Rezoning Transportation Analysis

Petition Number: 2018-067

General Location Identifier: 02919114, 02919115

Date	Description
07-23-2018	First Review

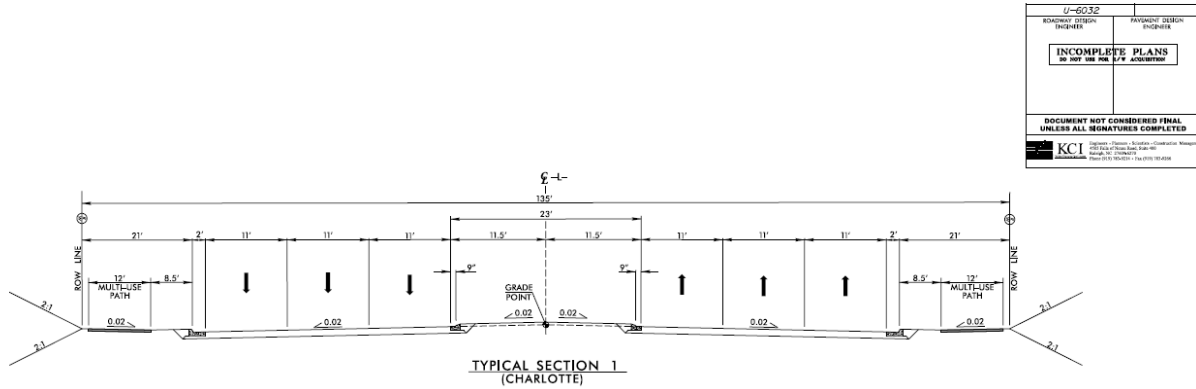
1. **Curbline** The proposed zoning district has a setback measured from back of the proposed future curbline. Mallard Creek Rd's future back of curb needs to be located 47' as measured for Mallard Creek Rd.'s existing centerline (see below Typical Section). This dimension and call-out needs to be depicted on the revised site plan.
